Huddersfield Railway Station

Application ref: 2021/65/94574/W

Variation of Condition 2

Prepared by Strzala Architects

Proposed Location Plan

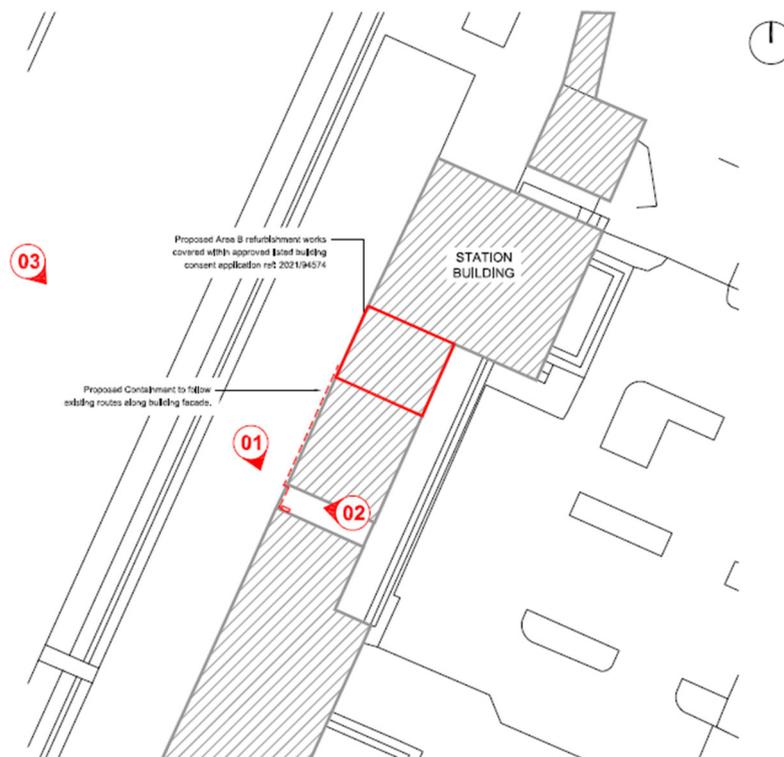
We request a variation to Condition 2 of approved Listed Building Consent ref: 2021/65/94574/W to include additional drawing ref: 2955-HUD-LB209 to revise the external air conditioning condenser position serving Area B of the approved development.

Due to limitations of pipework lengths of the air conditioning system proposed to serve Area B, it is the proposal to locate 1No. external condenser unit in a discrete location within the walkway leading to the passenger WC's on Platform 1.

Proposed AC Condenser Location

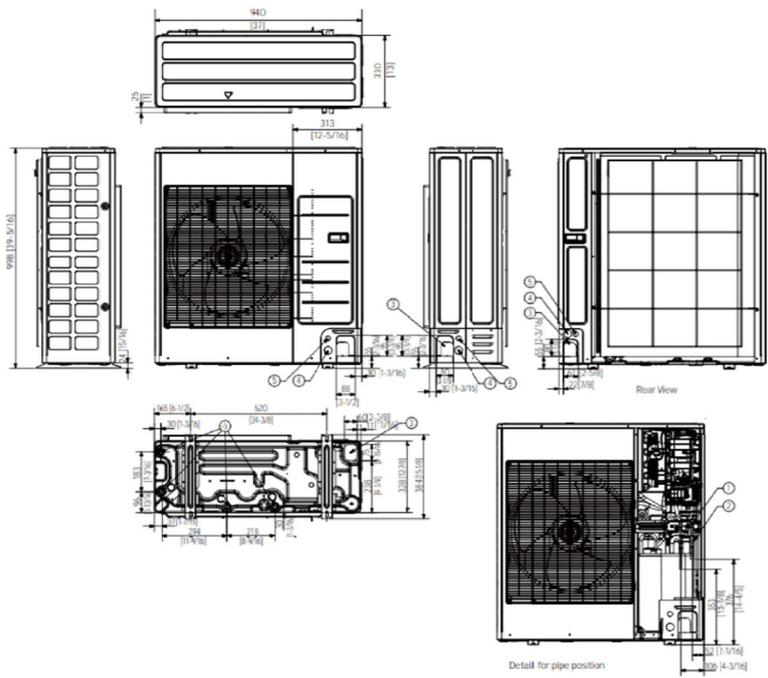
In order to mitigate any perceived negative impact to the heritage asset, the condenser unit is proposed to be situated at high level within the walkway area. The proposed location is obscured by the masonry bulkheads to both the main and platform elevations.

Existing Precedent to Platform 1 Elevation

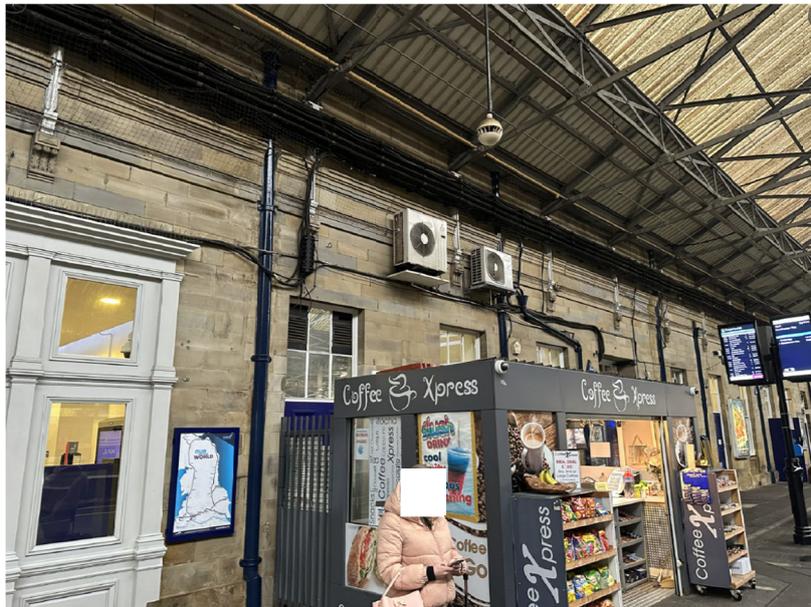
Details of the proposed condenser unit have been provided below, of similar type to those installed at present along the Platform 1 elevation:
